**CITY OF TEMPE
DEVELOPMENT REVIEW COMMISSION**

**Meeting Date: 04/23/2013
Agenda Item: 3**

ACTION: Request for a Development Plan Review and Use Permit Standard to reduce the side yard setback from 30 to 27 feet (10%), for a new restaurant drive-through building for MCDONALD'S RESTAURANT, located at 625 East Baseline Road. The applicant is Huellmantel & Affiliates.

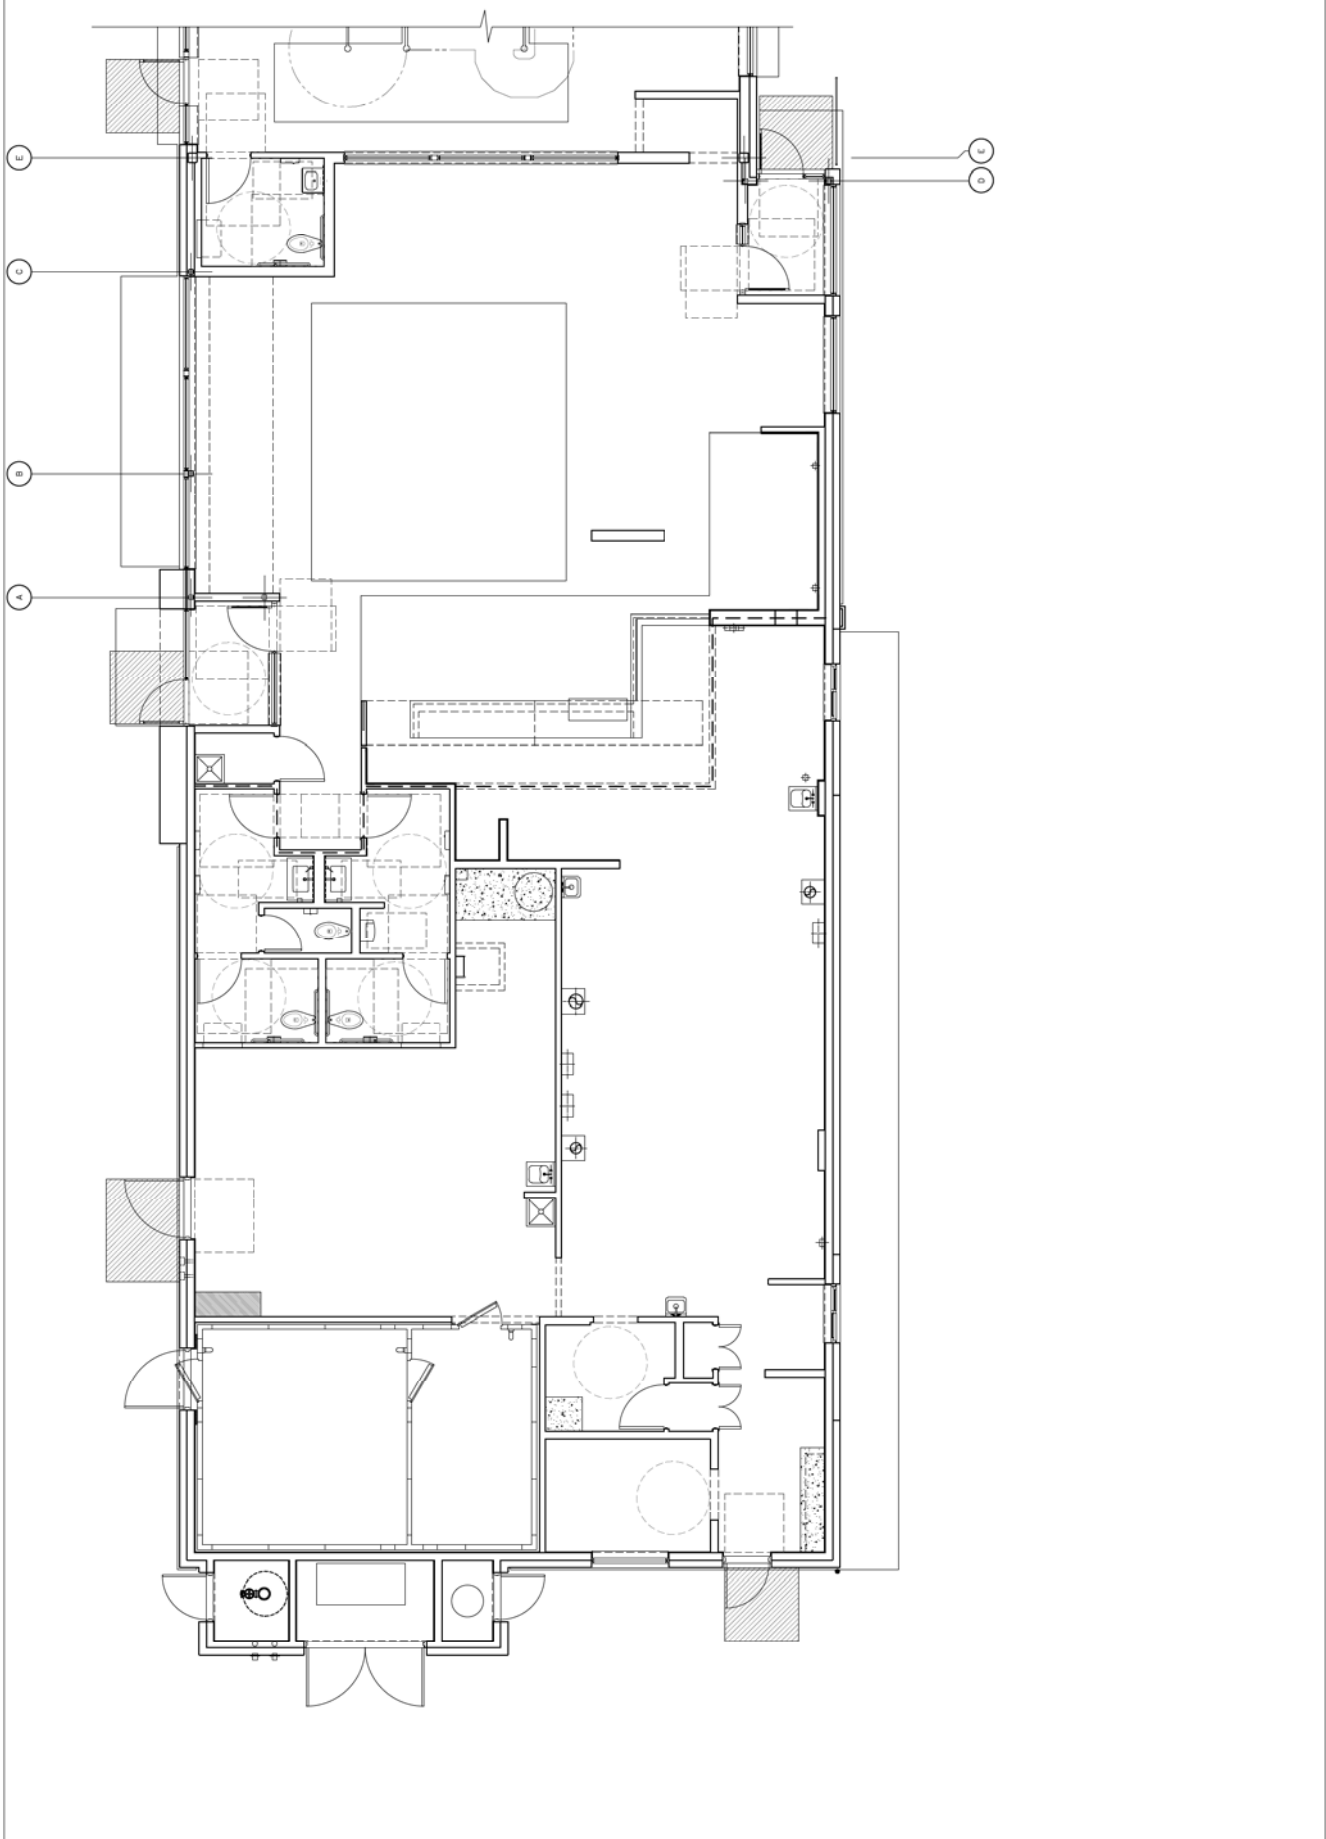
6. Public Restroom Security:
 - a. Lights in restrooms:
 - 1) Provide 50% night lights
 - 2) Activate by automatic sensors, key or remote control mechanism
 - b. Single user restroom door hardware:
 - 3) Provide a key bypass on the exterior side

LANDSCAPE PLAN

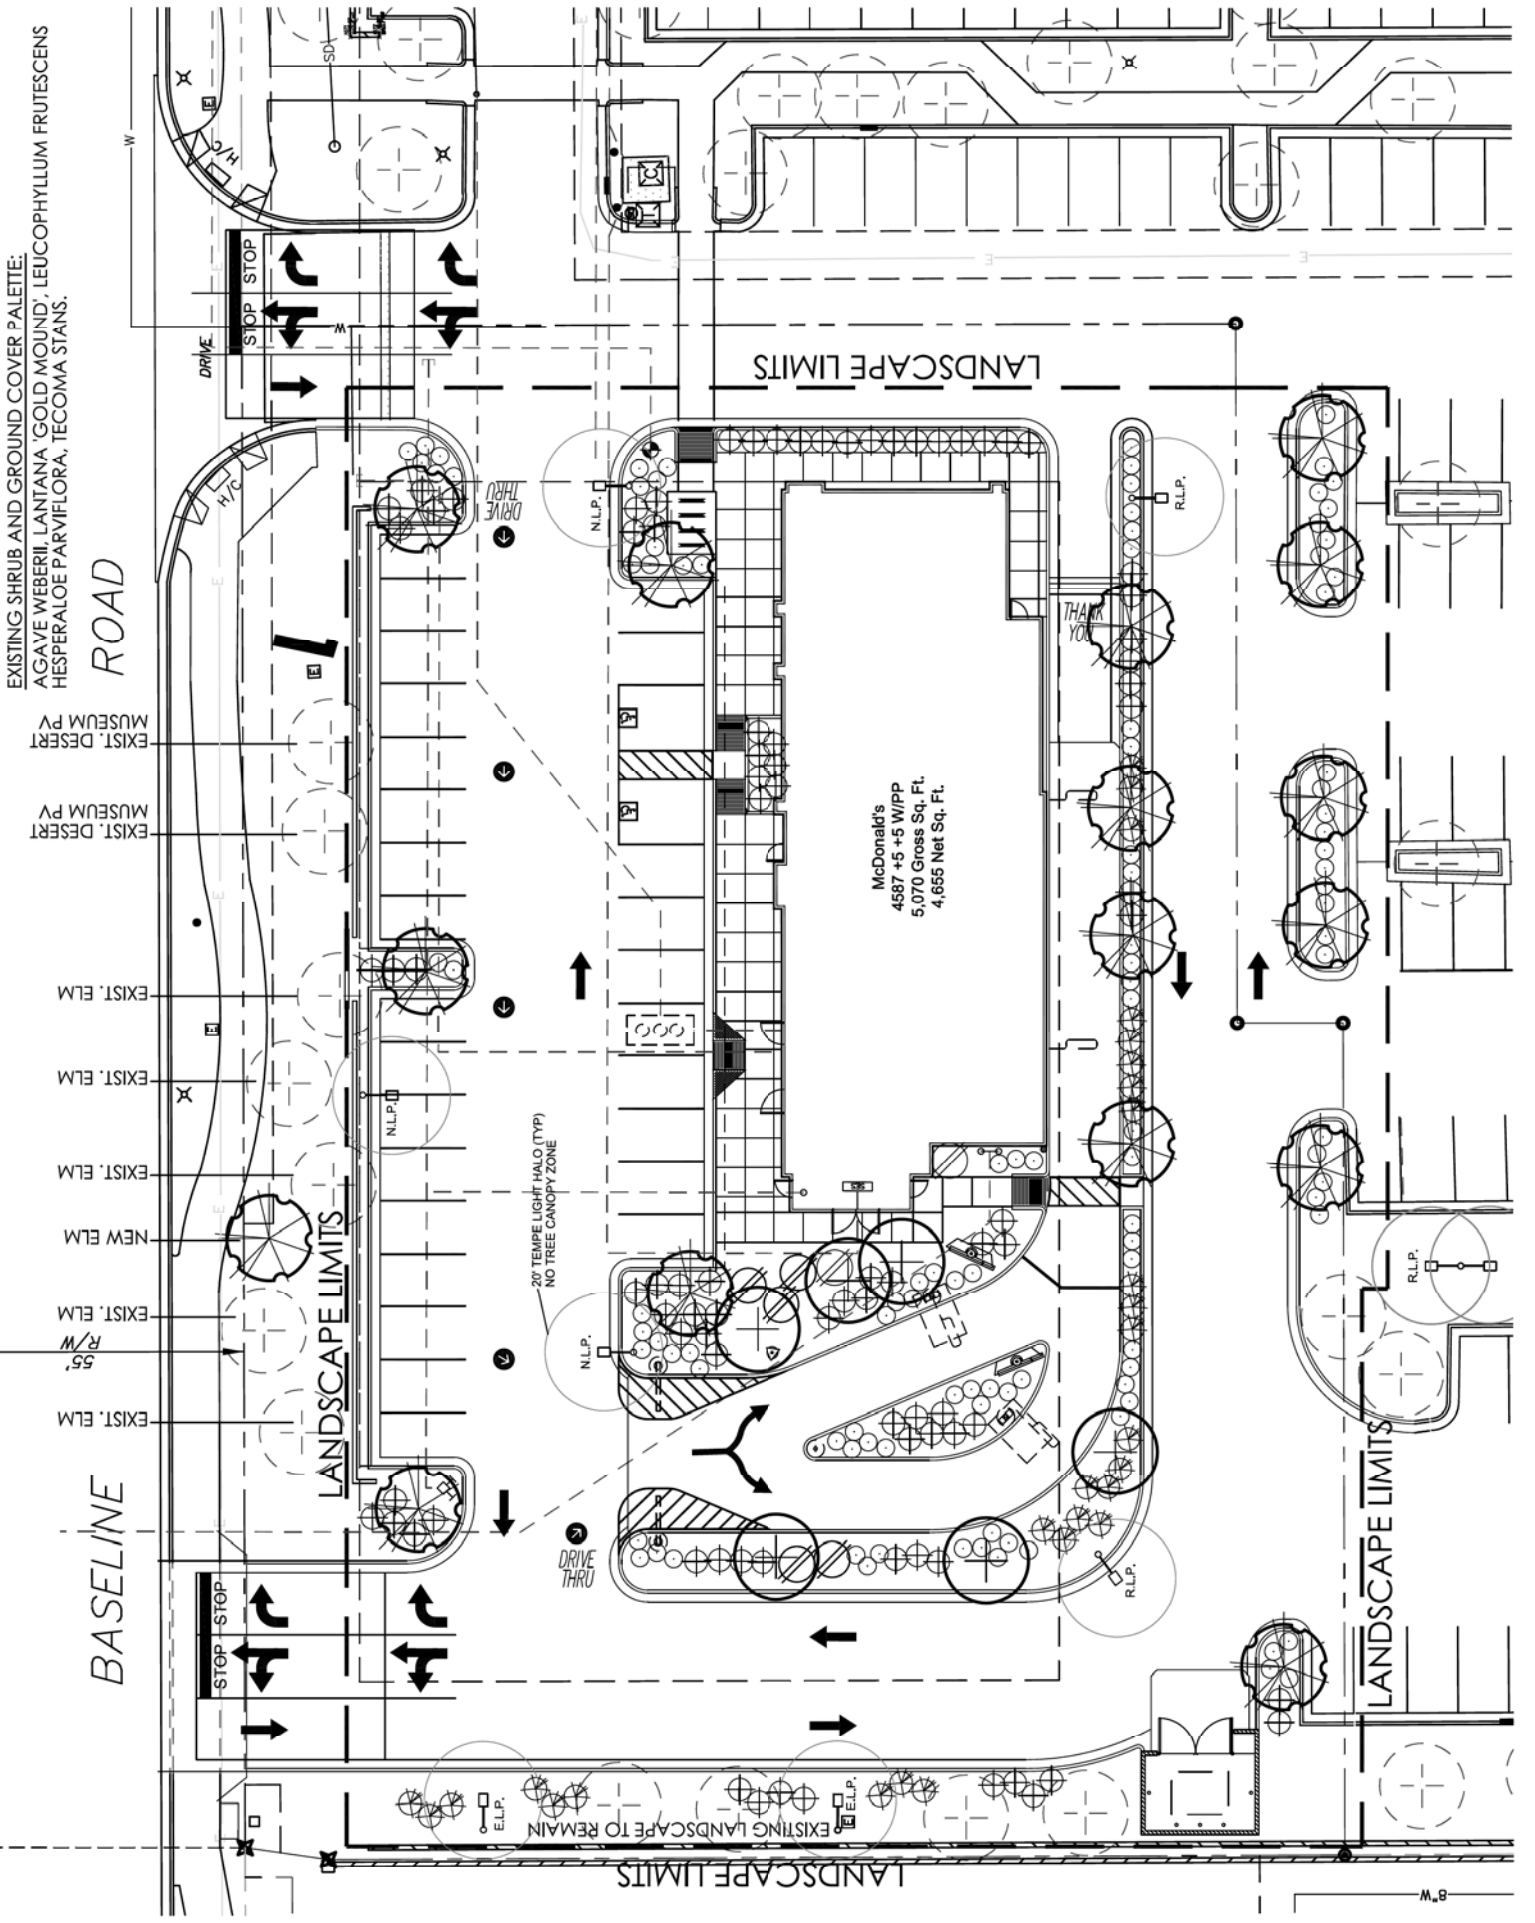
13. The plant palette is approved as proposed and specified on the landscape plan. Any additions or modifications may be submitted for review during building plan check process.

14. Irrigation notes:
 - a. Provide pipe distribution system of buried rigid (polyvinylchloride), not flexible (polyethylene). Use of schedule 40 PVC mainline and class 315 PVC 1/2" feeder line is acceptable. Class 200 PVC feeder line may be used for sizes greater than 1/2". Provide details of water distribution system.

15. Include requirement to de-compact soil in planting areas on site and in public right of way and remove construction debris from planting areas prior to landscape installation.

16. Top dress planting areas with a rock or decomposed granite application. Provide rock or decomposed granite of 2" uniform thickness. Provide pre-emergence weed control application and do not underlay rock or decomposed granite application with plastic.

17. Trees shall be planted a minimum of 12'-0" from any existing or proposed public water or sewer lines located on-site. Trees near the main water or sewer lines located within the right of way shall be planted at least 20'-0" away. Final approval subject to determination by the Public Works, Water Utilities Division.
